FIRST AMENDMENT TO THE
DRAFT
ENVIRONMENTAL IMPACT REPORT

GOBLE LANE
MIXED-USE DEVELOPMENT
FOR PLANNED DEVELOPMENT
REZONING
PDC02-066/NR05-001

SCH No. 2005022057

City of San José
June 2005

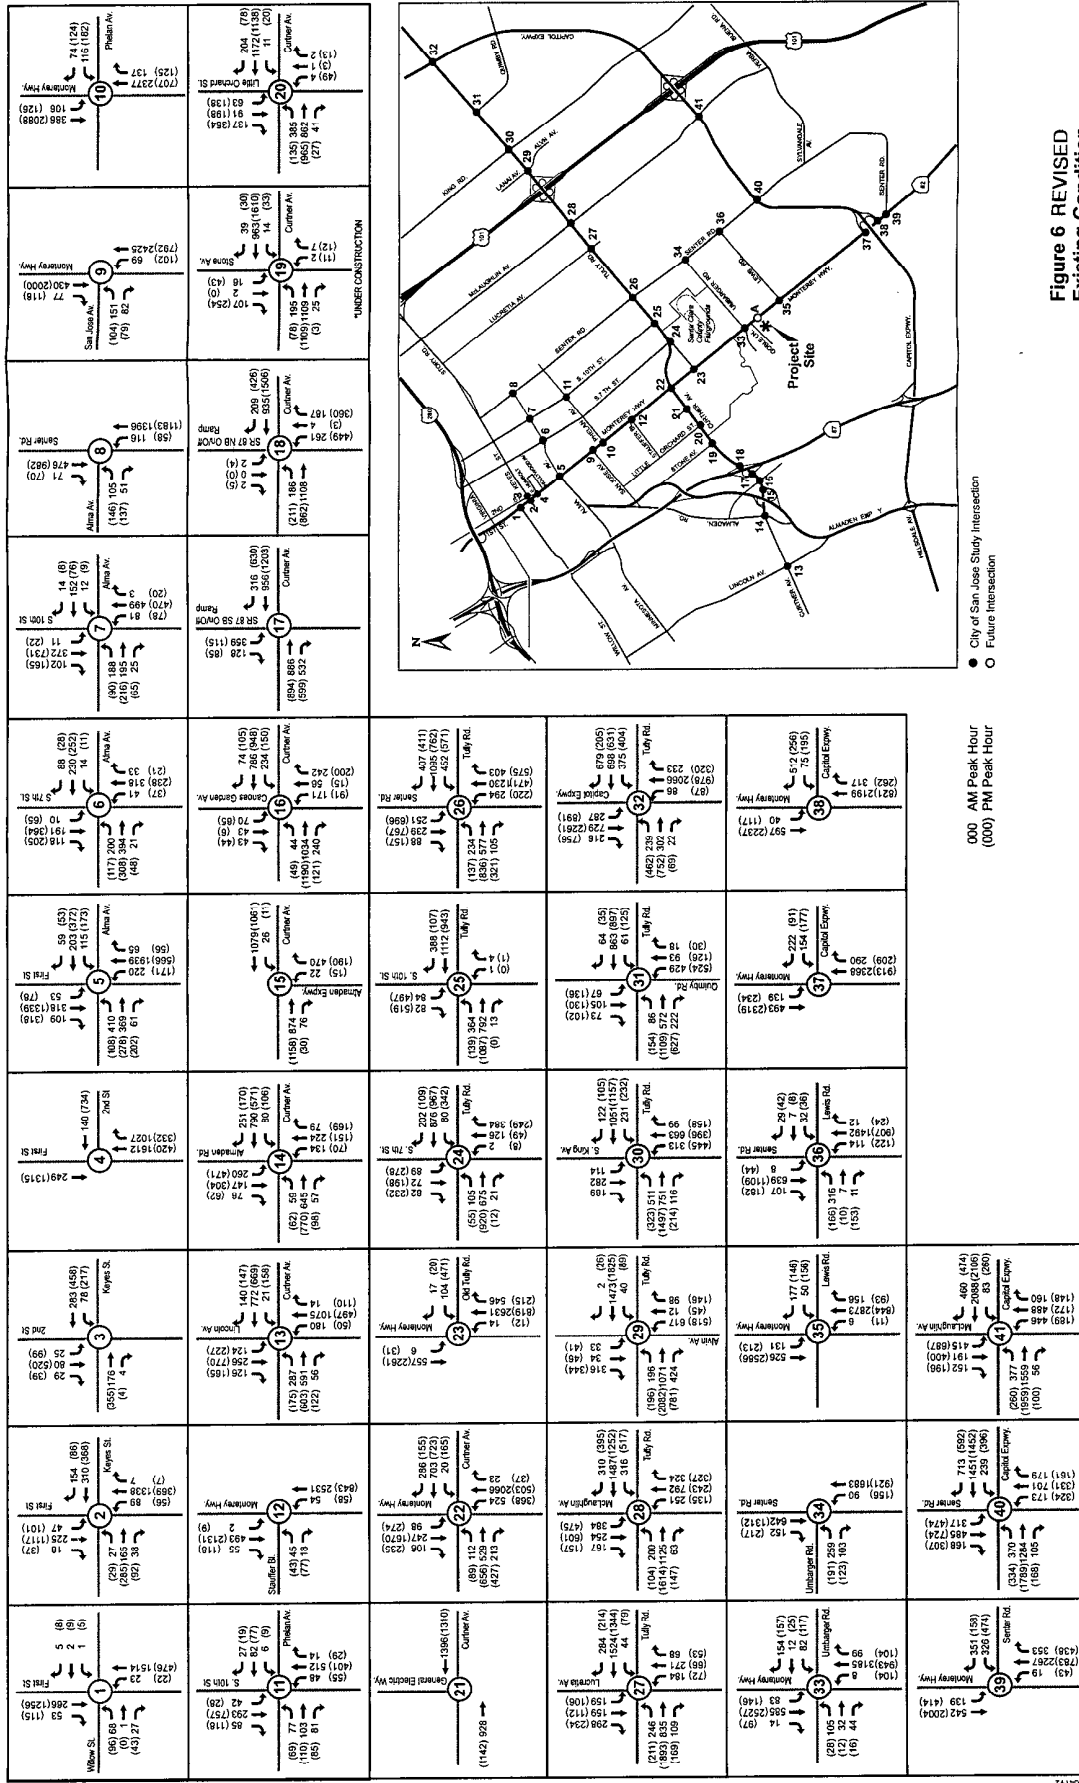
Comment C18: Figure 6: Volumes shown in this figure do not match volumes used in intersection analysis (Traffix) for intersections #2, #3 and #9. Which volumes are correct?

Response C18: The intersection analysis and volumes shown on the TRAFFIX worksheets are correct. Changes have been made to the Figure 6 to reflect the correct turning movement volumes. The corrections do not affect the impacts conclusions of the Draft EIR. The revised Figure 6 (page 20) is provided in Section IV of this document.

Figure 7 REVISED
Background Traffic Volumes
Weekday AM and PM Peak Hour

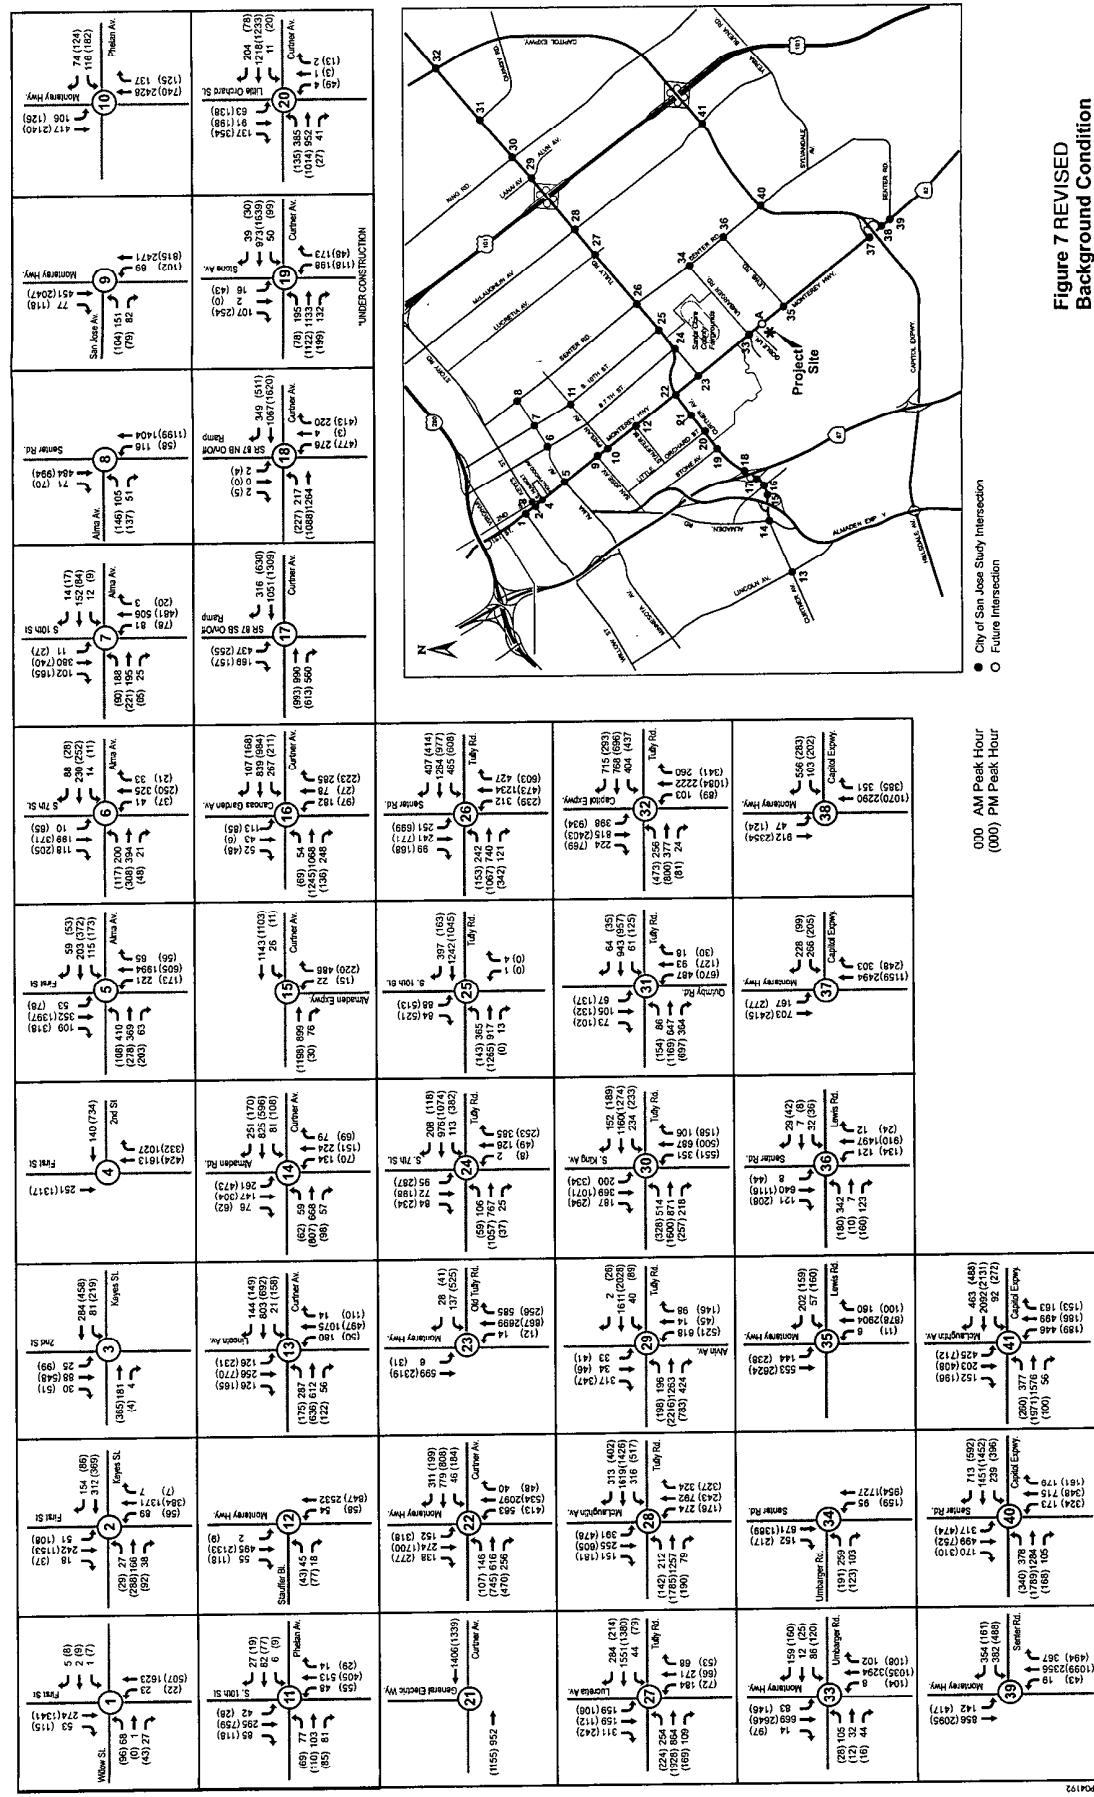
Comment C19: Figure 7: Volumes shown in this figure do not match volumes used in intersection analysis (Traffix) for intersections #1, and #22. Which volumes are correct?

Response C19: The intersection analysis and volumes shown on the TRAFFIX worksheets are correct. For intersection #22 the volumes do match and no edit is required. Changes have been made to the Figure 7 to reflect the correct turning movement volumes for intersection #1. The corrections do not affect the impacts conclusions of the Draft EIR. The revised Figure 7 (page 24) is provided in Section IV of this document. A complete copy of the revised TIA will be provided to Caltrans.

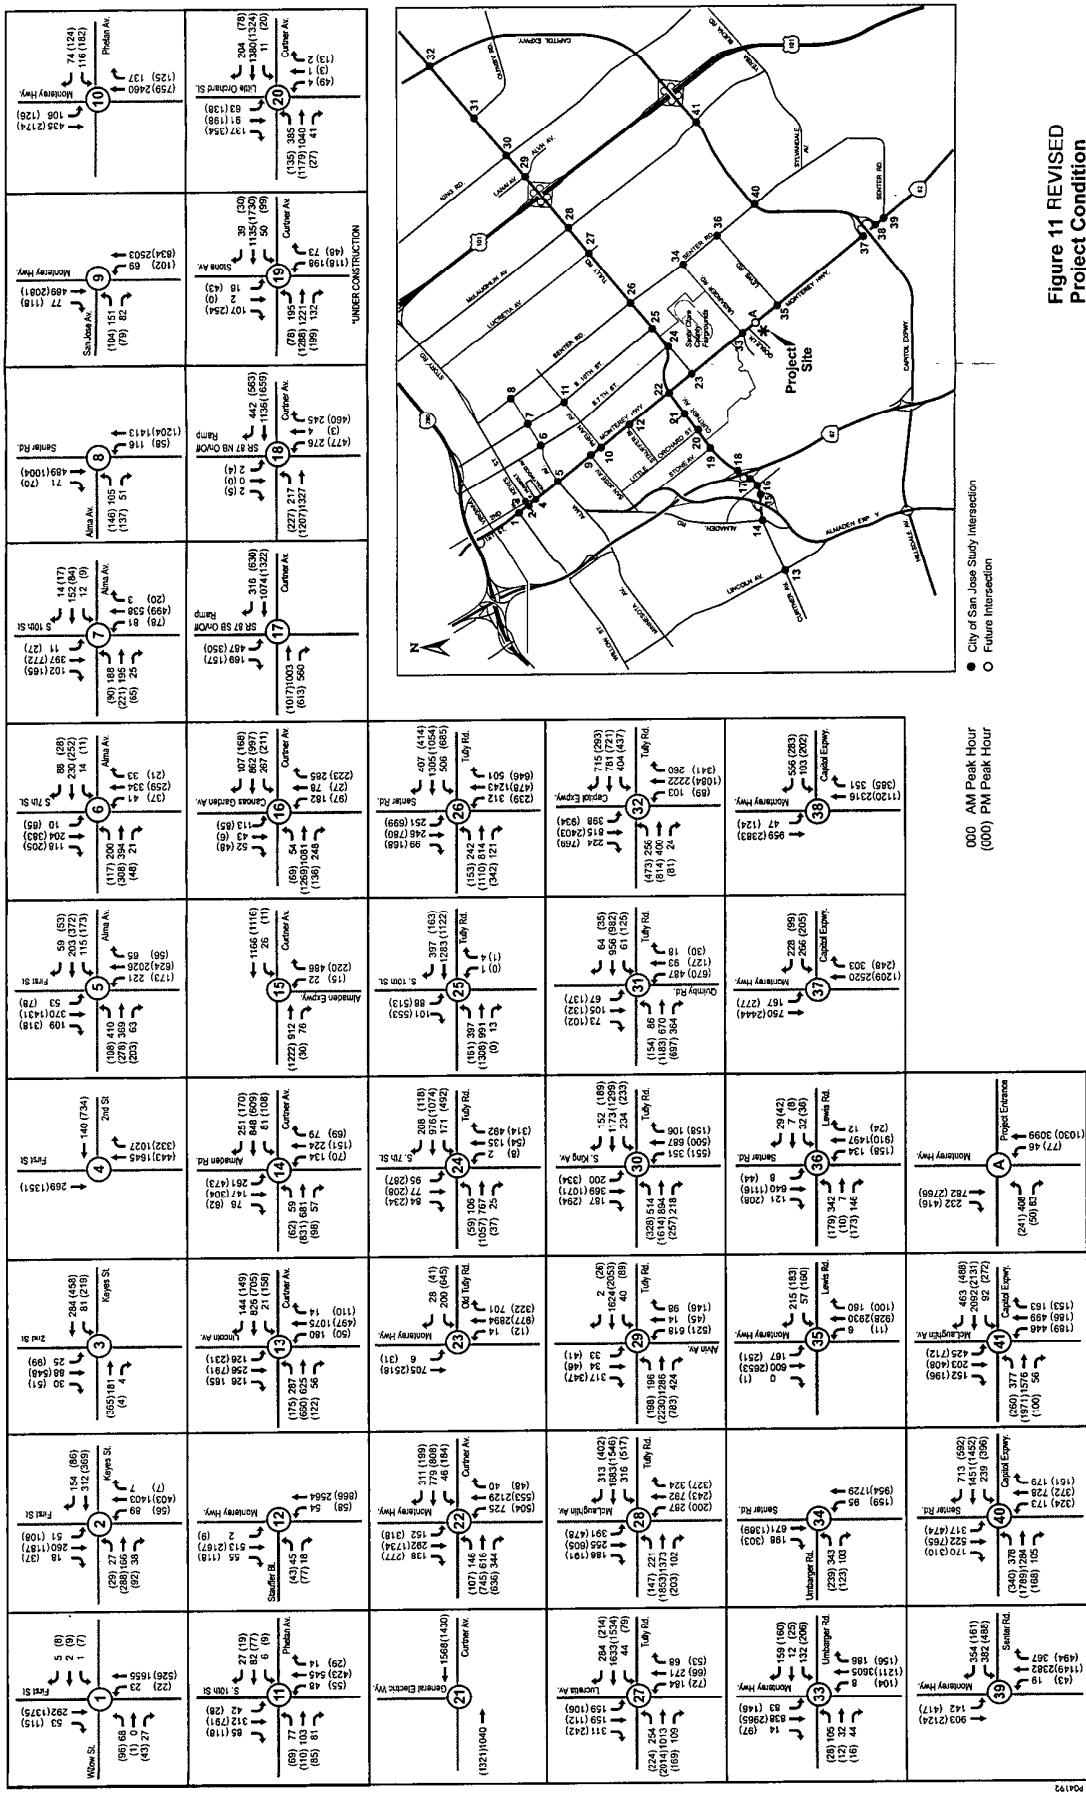
Comment C20: 20. Figure 11: Volumes shown in this figure do not match volumes used in intersection analysis (Traffix) for intersections #23, and #35. Which volumes are correct?

Response C20: The intersection analysis and volumes shown on the TRAFFIX worksheets are correct. Changes have been made to the Figure 11 to reflect the correct turning movement volumes. The corrections do not affect the impacts conclusions of the Draft EIR. The revised Figure 11 (page 33) is provided in Section IV of this document. A complete copy of the revised TIA will be provided to Caltrans.

Figure 12 REVISED
Cumulative Condition
Intersection Traffic Volumes
Weekday AM and PM Peak Hour

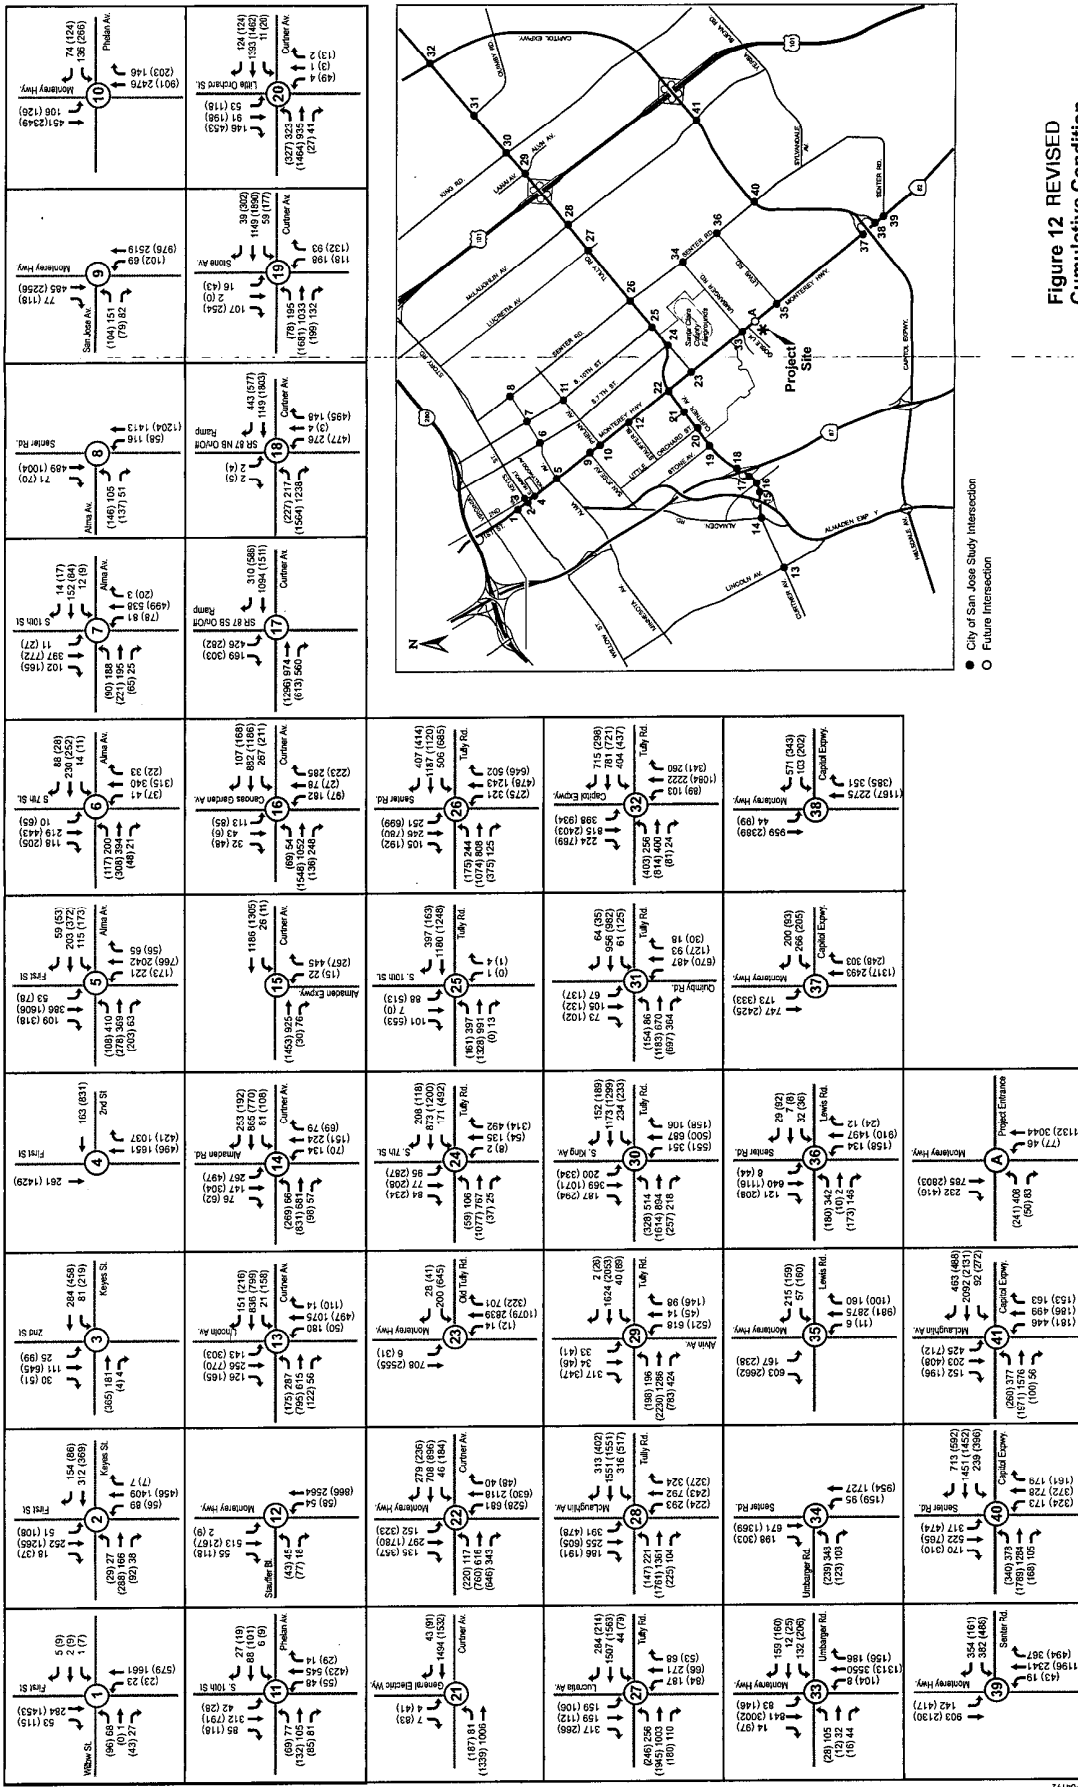
Comment C25: Figure 12: Volumes shown in this figure do not match volumes used in intersection analysis (Trafifix) for intersections #12, #17, #33 and #35. Which volumes are correct?

Response C25: The intersection analysis and TRAFFIX worksheets are correct. Changes have been made to the Figure 12 to reflect the correct turning movement volumes. The corrections do not affect the impacts conclusions of the Draft EIR. The revised Figure 12 (page 46) is provided in Section IV of this document. A complete copy of the revised TIA will be provided to Caltrans.

Intersection #42: MONTEREY HIGHWAY & PROJECT SITE ENTRANCE

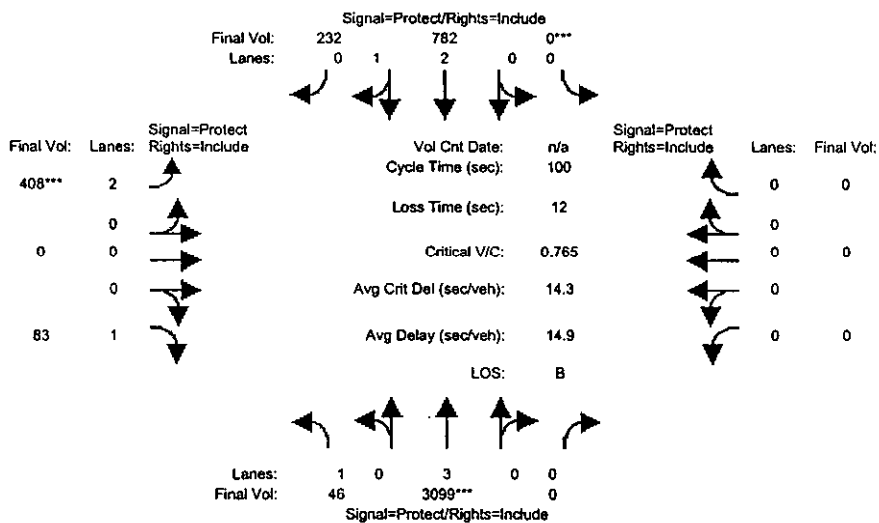
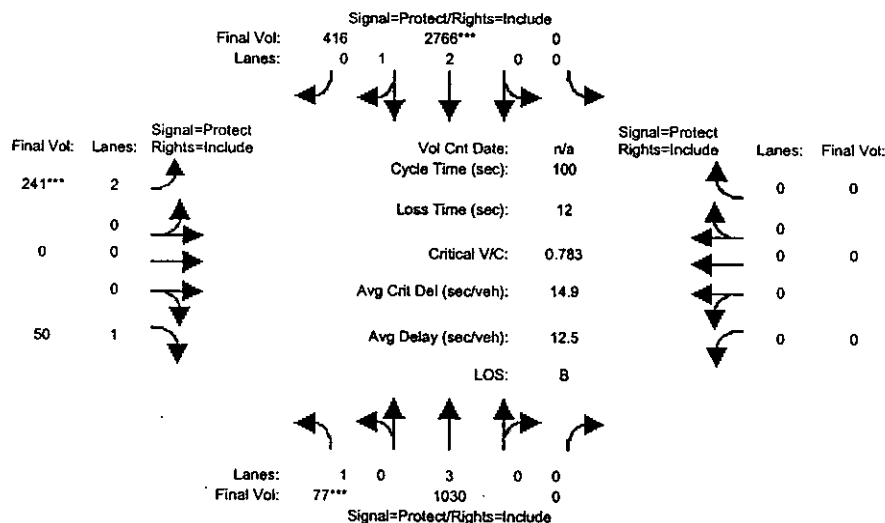
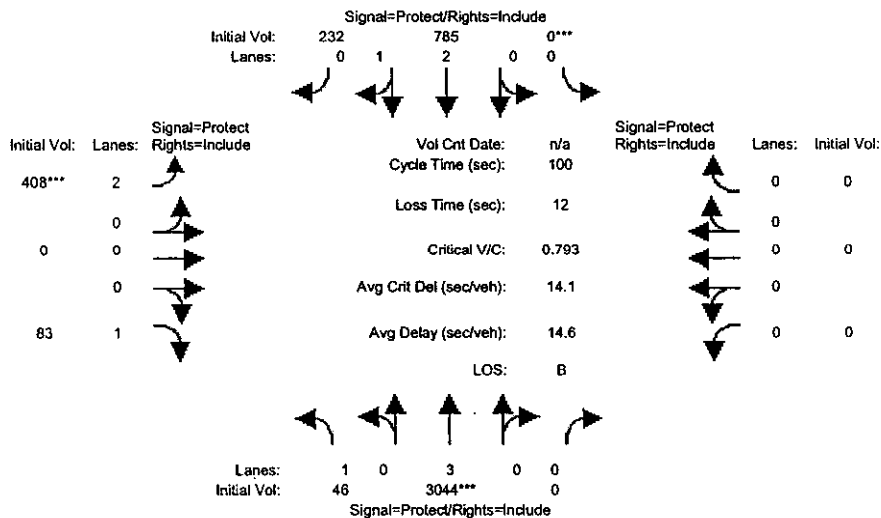
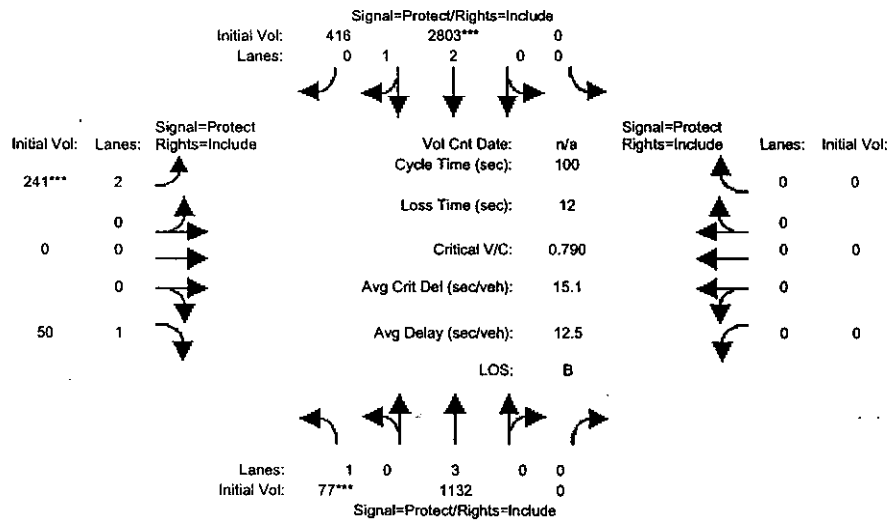
Comment C27: Project Conditions: The intersection analysis for intersection #42 is missing. Please submit one for our review.

Comment C28: Cumulative Conditions: The intersection analysis for intersection #42 is missing. Please submit for our review.

Response C27: The Project and Cumulative Conditions LOS TRAFFIX sheets for Intersection #42 are provided in Section VI of this document. A complete copy of the revised TIA will be provided to Caltrans.
